# Lincolnton NC

Public Hearing Staff Analysis  
CZ-1-2024  
East Gaston Street Ext., PID 89926

# STAFF COMMENTS /CONDITIONS OF APPROVAL

# LAND USE PLAN COMPLIANCE

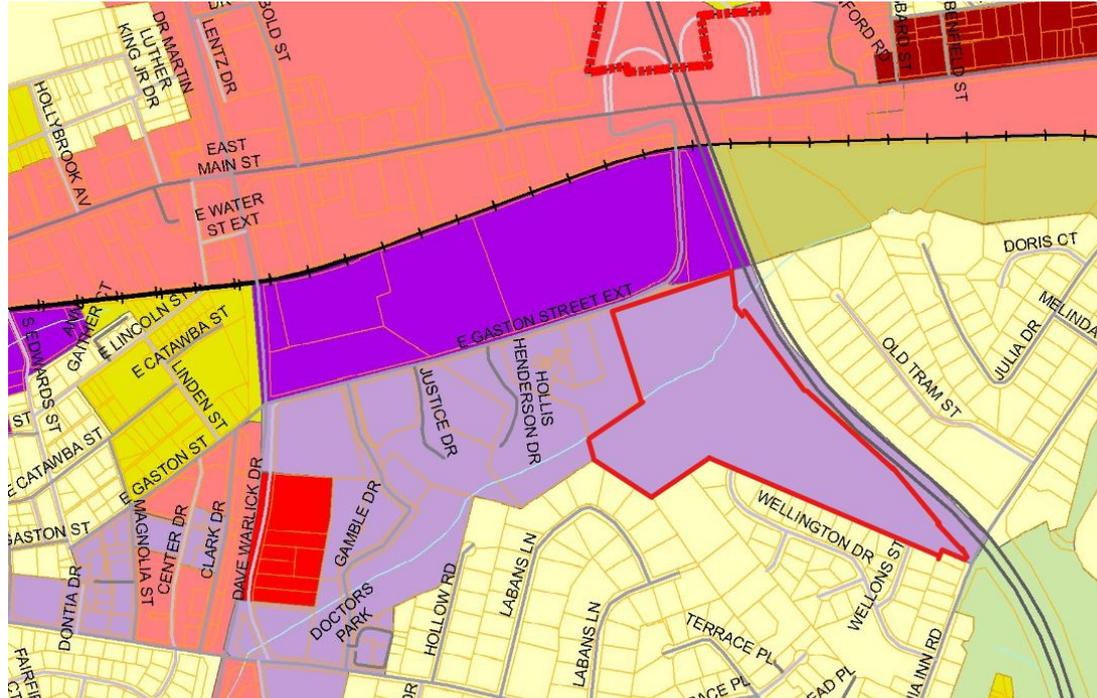
The land use plan shows the property in the mostly in the Neighborhood Business area with a portion in Institutional Office Planning Area.

**The development would be inconsistent with the Future Land Use Map. Amending the FLUP to show the area in the Mixed-Use Residential/Commercial Planning Area would be reasonable.**
